**Planning Commission Work Session
Council Chambers
July 25, 2022 – 4:30 p.m.
233 South Main Street, Monroe, Ohio**

Work Session regarding Hyde Park at the Crossings, a proposed residential development at Roden Park Drive and Crossing Boulevard.

I. Work Session regarding Hyde Park at the Crossings Development Proposal

PRELIMINARY PUD PLAN

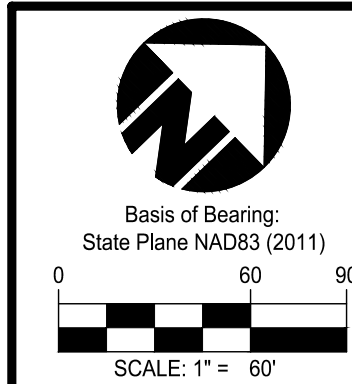
Open Space Standards- 1213			
Buffer Type A required adjacent to R-2 zoning	N Buffer Type A is required along the eastern edge of the development fronting Crossings Boulevard as there is R-2 zoned property on that side.	N Buffer Type A is required along the eastern edge of the development fronting Crossings Boulevard as there is R-2 zoned property on that side. However, in conversation at the 2/15 meeting, Planning Commission did state a preference for landscaping in this area to remain consistent with existing landscaping along Crossings Boulevard.	- Buffer Type A is required along the eastern edge of the development fronting Crossings Boulevard as there is R-2 zoned property on that side. However, in conversation at the 2/15 meeting, Planning Commission did state a preference for landscaping in this area to remain consistent with existing landscaping along Crossings Boulevard as shown by the applicant.

Minimum 1 acre formal open space required	- Overall space has been designated. Refined plans should be provided to understand how space will be utilized.	- More detailed plans have been provided to show the programming for these formal open space areas. Formal open space areas include walking paths, charcoal grills, benches, and pavilion space.	Y More detailed plans have been provided to show the programming for these formal open space areas. Formal open space areas include walking paths, benches, and pavilion space.
Minimum 3 acres open space required	Y Meets requirement.	Y Meets requirement.	Y Meets requirement.
Parking and Loading- 1211

2.5 off-street parking spaces per dwelling unit. (101x2.5= 252.5, ~253 spaces required)	N	Each of the 101 units will include a private 2-car garage, equaling 202 off-street parking spaces. Driveway space does not count toward this requirement. 50.5 (51) total off-street spaces would be required by code.	N	Of the 50.5 (51) total off-street spaces would be required by code, the applicant is now providing 26 off-street parking spaces and 34 on-street parking spaces.	-	Based on 83 units, 207 off-street parking spaces are required. Driveway space does not count toward this requirement. With each unit containing a 2-car garage, 166 off-street spaces are provided. Though driveway space does not count toward this requirement in the R-4 zoning, an additional 166 driveway parking spots are provided. In addition, the applicant is now proposing streets to meet City specifications and is open to dedication of the roads so ample on-street parking would also be available.

Subdivision Design Standards- 1208						
Street design standards	N	Applicant is proposing a 25-foot two way street, where the minimum is 28 feet.	N	Applicant has widened portions of Kings Cross Ln to 28-feet wide in areas where on-street parking is shown. All other areas remain 25-feet wide. While this is an improvement from the previous plan, it still does not meet the City standard of 28 feet. Fire appears satisfied with this layout from a safety services access perspective.	Y	The applicant is now proposing roadways built to City public street design and construction standards. The applicant is open to dedicating the internal roadways.
		Sidewalk is proposed directly against curb as opposed to curb-tree lawn-walk.		Sidewalk is proposed directly against curb as opposed to curb-tree lawn-walk. This deviates from City standard for streets.		
		Applicant may be proposing a non-standard curb.		Applicant may be proposing a non-standard curb.

Sidewalk requirement	N	Applicant is proposing a 5-foot walk behind curb on one side of the street on internal streets.	N	Applicant is proposing a 5-foot walk directly behind curb only on one side of the street on internal streets. This deviates from City standard for streets which would typically include 5-6 feet of tree lawn behind curb and a 5-foot walk behind the tree lawn.	Y	Applicant shows a 5-foot sidewalk on both sides of the street on all internal streets.
		Applicant is not showing required walk on complete frontage on Roden Park Drive and Cold Water Drive.		At the 2/15 Planning Commission meeting, the applicant indicated a willingness to install the full length of sidewalk required on Cold Water Drive. However, there still remains a gap in the walk required on Roden Park Drive between Cold Water Drive and Enfield Lane.	N	There remains a gap in the walk/path required on Roden Park Drive between Cold Water Drive and Kings Cross Lane where the creek is located.

Street tree requirement	N	Applicant is not currently proposing street trees as required in the tree lawn.	N	On the internal side of the development, the applicant is not currently proposing street trees as required in the tree lawn as there is no tree lawn. Along Roden Park Drive external to the development, canopy trees are shown behind the public walk, not in the right-of-way. Some but not all trees are spaced 40 feet on center.	Y	Based on the renderings provided, it now appears street trees are shown on all streets in the tree lawn as required.
		Applicant is proposing some trees in the front yards (behind walk) throughout the development but not necessarily every 40 feet on center and not on both sides of the street.		Applicant is proposing some trees in the front yards (behind walk) of units throughout the development but not necessarily every 40 feet on center and not on both sides of the street.	-	A formalized landscape plan will provide more detail as to whether street trees are 40 FT on center as required.
